Welded structure

General machining tolerances UNI 5307-43								
Tolerance	< 6	6-10	10-120	120-315	315-1000	1000-2000	2000-4000	> 4000
Linear dim.	±0.1	±0.2	±0.3	±0.5	±0.8	±1.2	±2	±3
Angular dim.	±1'	±30'	±20'	±10'	refer to the nearest size			
designed by						R.De Salvo		
LIGO PROJECT						G. Gennaro-PROMECH		
date						27-01-06		
sheet						1/3		
title						LIGO-D051196-01-D		
part						190		
scale						A 1

196

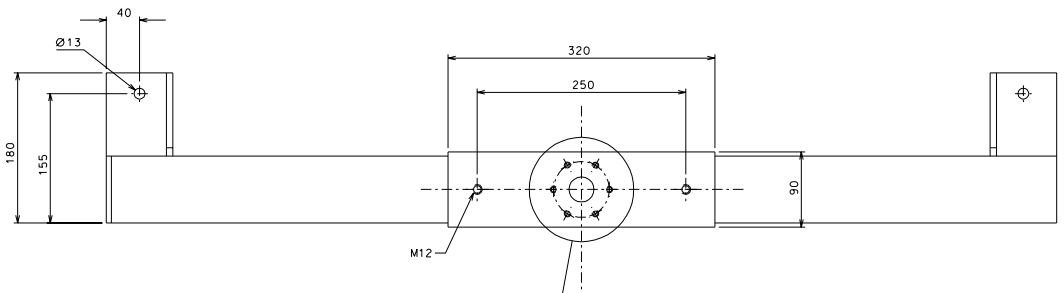
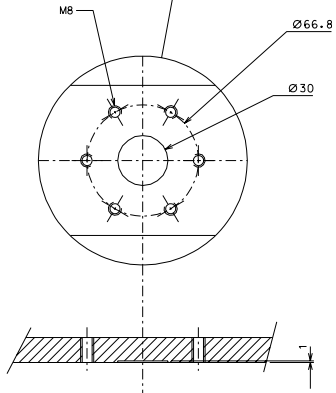
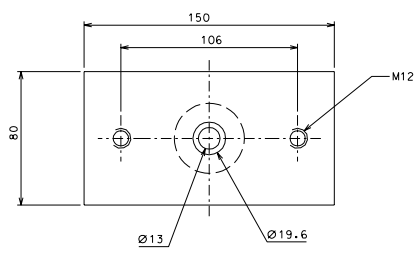
added blind hole on part 196				19-04-06	
ref.	date	signature			
modifications					
198	4	EN 6082	2/1		
196	4	EN 6082	1/1		
ref.	date	signature	date	signature	date
